RE: S4.55(1A) MODIFICATION APPLICATION TO SSD 17_8963 IN RELATION TO THE STAGE 3C DEVELOPMENT AT LISMORE BASE HOSPITAL

This Statement has been prepared for NSW Health Infrastructure (HI) on behalf of John Holland Group (JHG) by City Plan Strategy and Development Pty Ltd (City Plan), to accompany an application under Section 4.55(1A) of the Environmental Planning and Assessment Act 1979 (the Act).

Figure 2 Proposed Amended Level 7 Plan (Source: CGA)

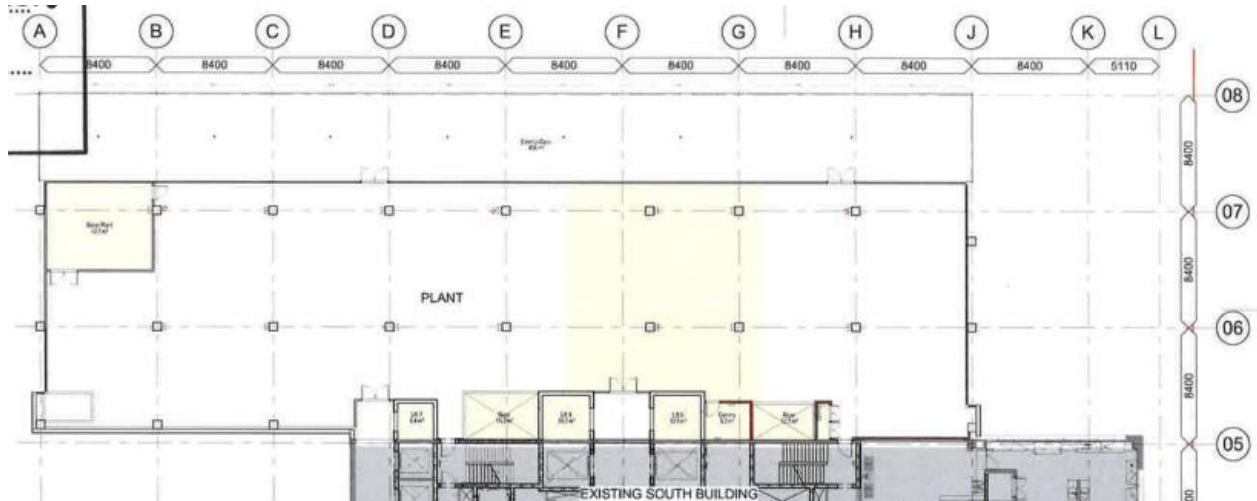
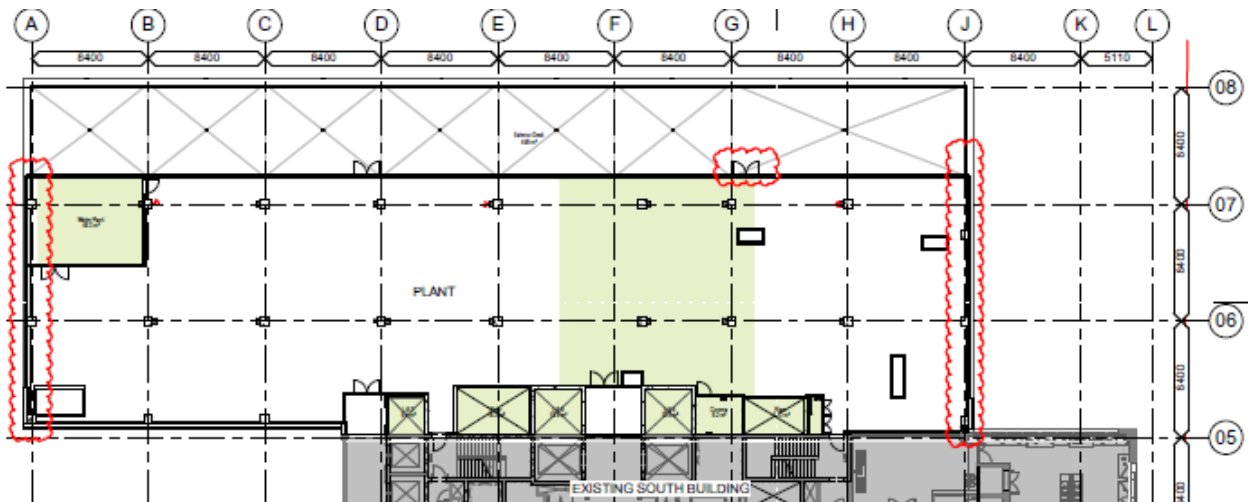
- Level 7: The primary changes at Level 7 of the approved NTX comprise a repositioning of the east and west façade louvres to align with the external face of structural columns (to match the existing Stage 3B1 South Tower) and relocation of one of the plant space louvre doors to properly align with the internal plant layout. Refer to the following figures for a comparison between the approved layout for Level 7 and proposed amended layout.

Figure 4 Proposed Amended Roof Plan Layout (Source: CGA)

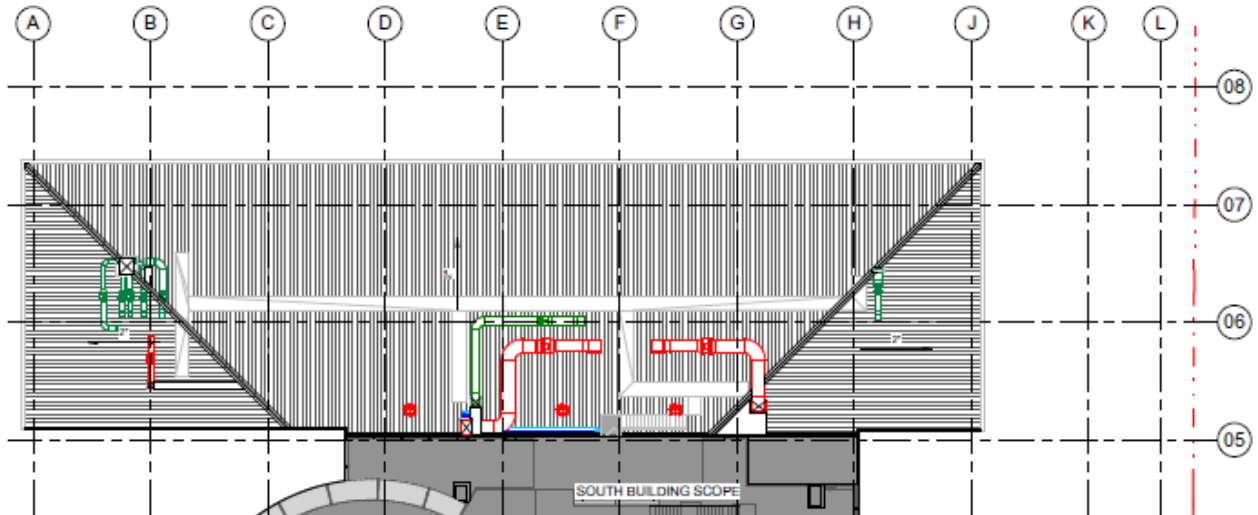
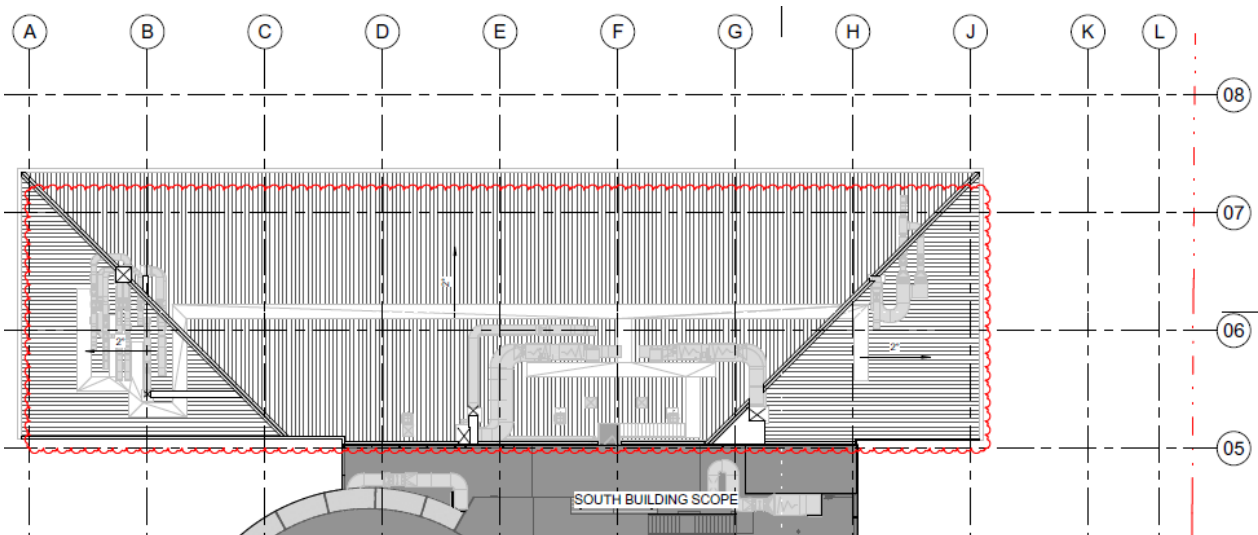
- Roof Level: As can be seen in the comparative figures that follow, the extent and design of rooftop mechanical plant is proposed to be amended. The mechanical plant design has been updated following detailed plant selection and to ensure compliance with the relevant standards.

Figure 7 Proposed Eastern and Western Elevation Plans (Source: CGA)

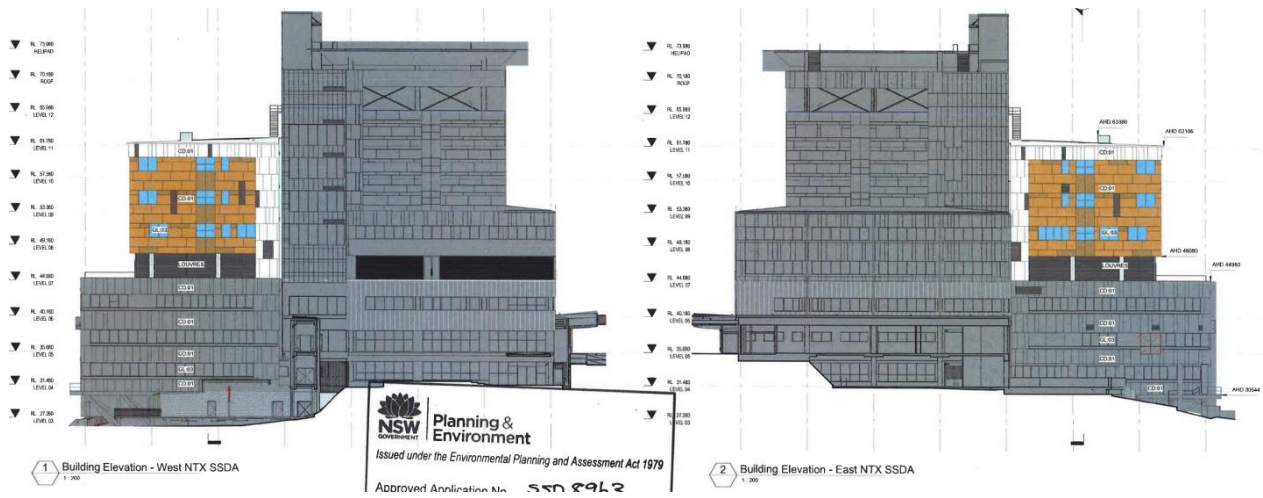
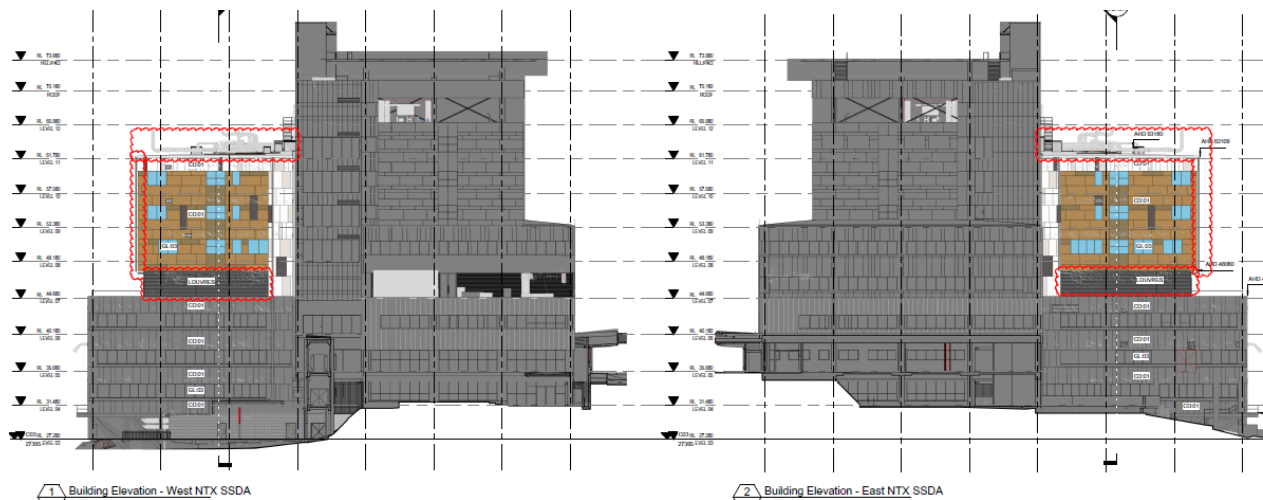
- East/west elevations: As can be seen in the comparative elevation plans on the following page, a series of changes have been made to the east and west elevations of the approved NTX. Downpipes are now shown (detail not previously shown in elevation and only on plan), mechanical louvres have been added to the façade in nominated locations for separation distance compliance to the relevant standards, the louvres at Level 7 now align with the external face of structural columns and as with the northern elevation, the rooftop mechanical plant has been amended (visible on all elevations) as per the northern elevation.

Figure 8 Approved vs Proposed Amended Southern Elevation Plans (Source: CGA)

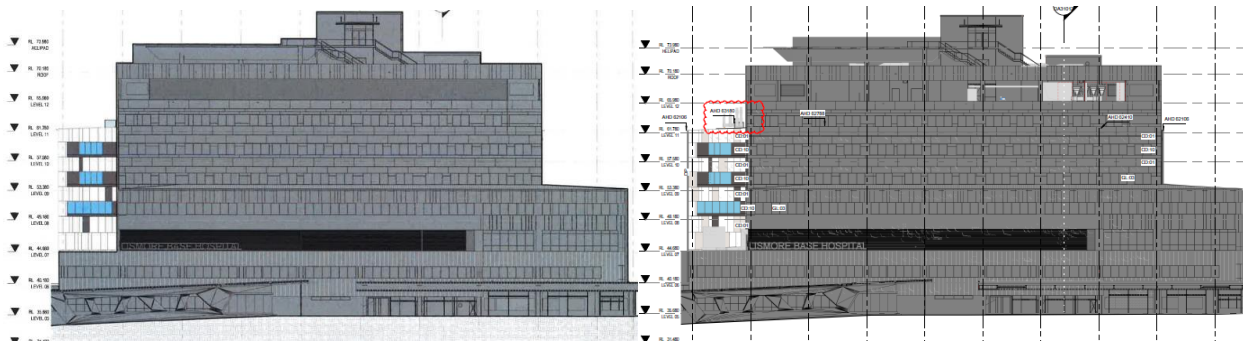
- South elevation: As can be seen in the following comparative elevation plans, the modified rooftop mechanical plant is also visible on the southern elevation, as per the northern elevation.
